Docket Item #17 SPECIAL USE PERMIT #2004-0009

Planning Commission Meeting May 4, 2004

Consideration of a request for a special use permit to operate a restaurant.

1301 North Quaker Lane

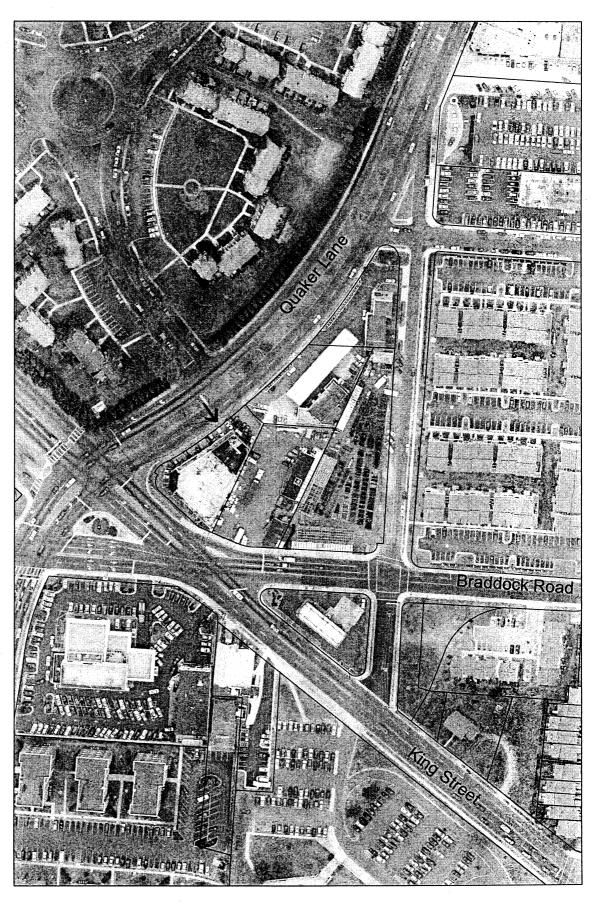
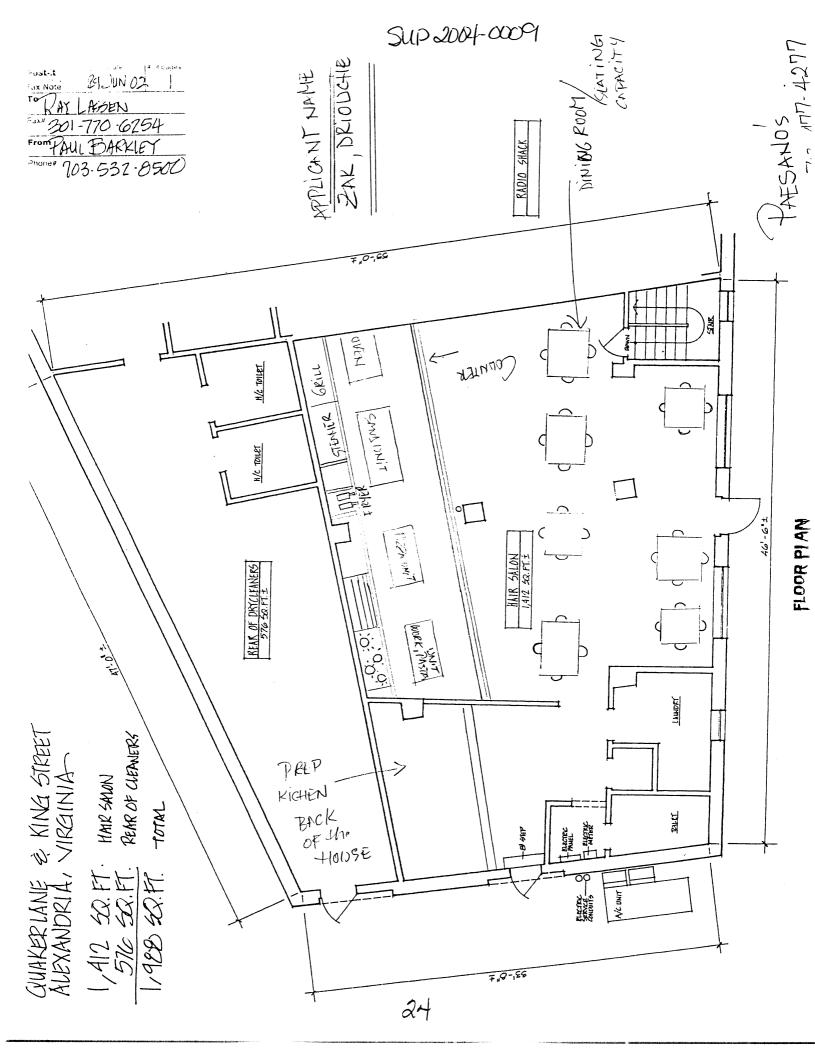
F-1 The submitted sketch is not sufficient in detail or dimensions to provide enough information to conduct a complete review. (Submitted plans indicate a hair salon will be used in combination with the requested restaurant. This type of use is incompatible within the same tenant space. Plans also indicate stairs. Stairs used as a means of egress from another tenant space shall not discharge into the proposed

- tenant space.) Therefore, additional requirements beyond those stated below may be applicable, should conditions arise which have not been included within the submitted application.
